INDESIT company

Model type:
C238.1

Commercial code:
F027175

Solenoid valve Elbi 368 (photo NT005400)
Solenoid valve Bytron 510 (photo NT005500)

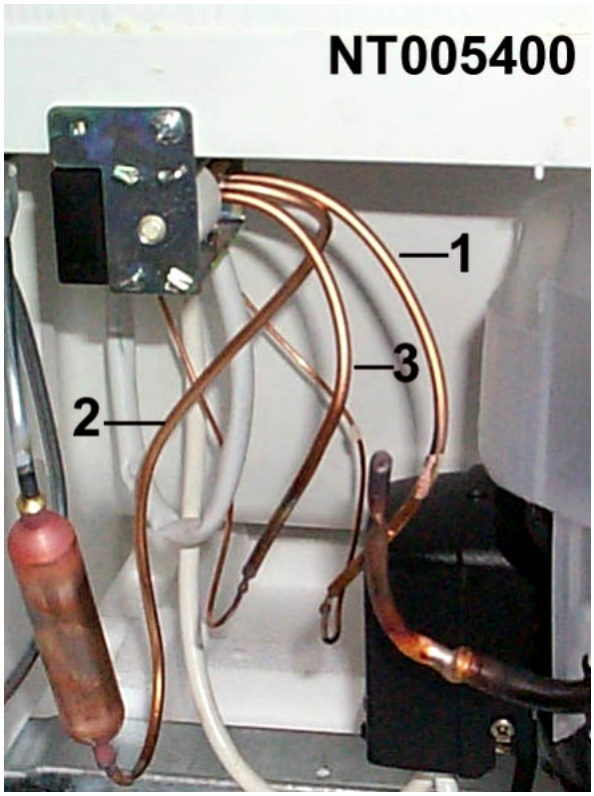
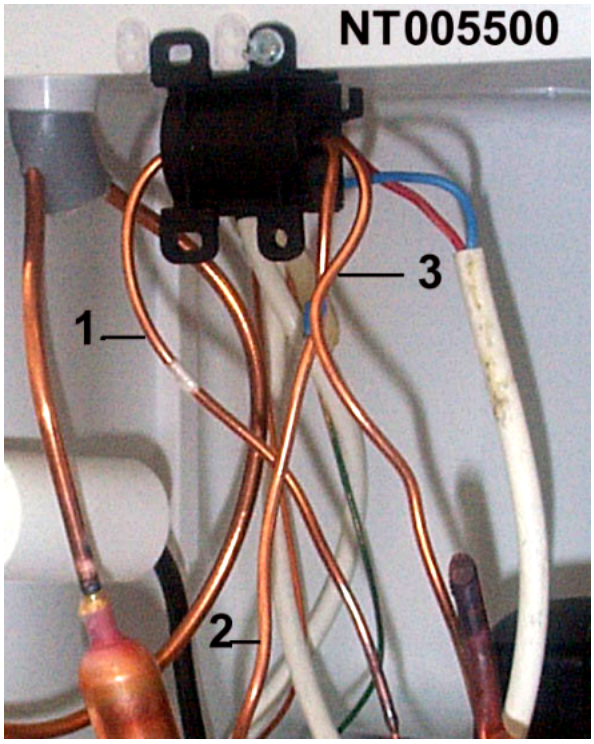
n1030026: Solenoid valveBytron-510 for combined products Ariston-Indesit of series 2000

From the half of July 2001 the production of Melano is using on the combined products Ariston and Indesit, belonging to series 2000, a new three-way solenoid valve - model Bytron-510 to 220-240V 50/60Hz for gas R134A and R600A.
There is only an exception for the models Ariston with display, which continue to use the solenoid valve Elbi 368.
The new solenoid valve Bytron- 510 has the same technical and working features of the preceding one (Elbi 368), although it is built up differently because for the following reasons:

1) The body on plastic with four fixing-points (two for sides): at first it was metal only with a fixing-point.
2) The location of the three tubes (at first they were on the same right side with the central entry) now are subdivided in this way: two of them are on a side (long-entry and short-exit for the freezer-evaporator) and one of them is on the opposite side (the other exit for the refrigerator-evaporator).
Moreover, the external diameter of tubes was 4 mm, and now it is 3 mm.
3) The probable bending of tubes and their length, although they are different between the two solenoid valves, are not binding for the assembly.

During the assembly on the product (left side of the compressor-zone) its location/fixing is not changed excepting for the type of nail 4x15 for the model Elbi-368 and of 2,9x9,52 for the model Bytron-510.
Moreover a new molecular filter 078983 is used to couple with the 3mm entry-tube (at first on the model Elbi-368 the filter 064790 was installed to be coupled with the 4mm entry-tube).
As spare part, only the solenoid valve Elbi-368(075616) will be managed and in the case of its use instead of the Bytron-510, also the molecular filter (078983) will be substituted with the other one (064790) because of the problem of the diameter of tubes.

P.S. We have to remember that, apart from the kind solenoid valve, the tube with the white little sign has to be connected to the capillary of the refrigetor-evaporator marked with white paint.
Moreover to understand better the difference, two images have been made (NT005400 and NT005500) relating to the solenoid valves, on which the location of tubes has been underlined with the numbers (1-2-3):
1) capillary for refrigerator-evaporator (exit)
2) molecular filter (entry)
3) capillary of freezer-evaporator (exit)

VECCHIA / OLD
NUOVA / NEW
N1030066FIG1

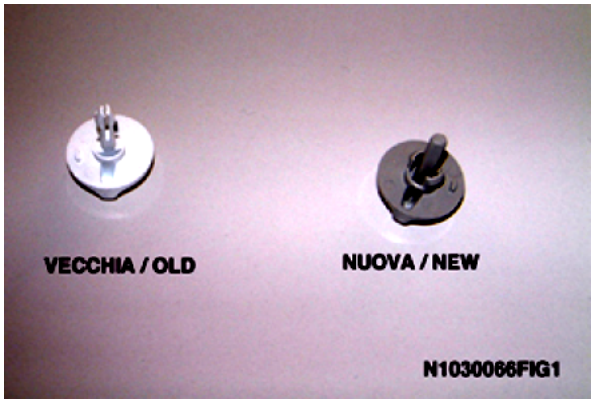
n1030066: Modification of trimmer knob on Ariston Opera-60 and Indesit fridge-freezers

In November 2003 (serial no. 31101.0001) the Melano factory replaced the control panel knob with rear expansion on Ariston Opera-60 and Indesit fridge-freezers (see fig.1).
This modification solves the problem of card damage and facilitates removal, that previously was only possible using tweezers.
With the new solution the knob locks on the control panel and not on the card trimmer.
For disassembly or removal, the knob must always be set (as the previous one) to stop = dot (see fig. 2).
This is necessary in order to fit or extract the knob pin from the trimmer without damaging it, after which the knob can be set to the desired operating position.
To remove the knob from the trimmer, lightly press the pin; when refitting, protect the trimmer with fingers to avoid damaging the card.
When working on the card or control panel make sure to always insert the card before fitting the knob.
The new knobs can also be fitted on premodification models; Service codes will remain the same, after replacing stocks.

080610 - TRIMMER KNOB BROWN-18
080611 - TRIMMER KNOB YELLOW (mass)
084424 - TRIMMER KNOB YELLOW-1003 (varnished)
082976 - TRIMMER KNOB ALUMINIUM-MET
083769 - TRIMMER KNOB SILVER
082116 - TRIMMER KNOB BLUE
078476 - TRIMMER KNOB SILVER- 647
075608 - TRIMMER KNOB WHITE replaced with 175020
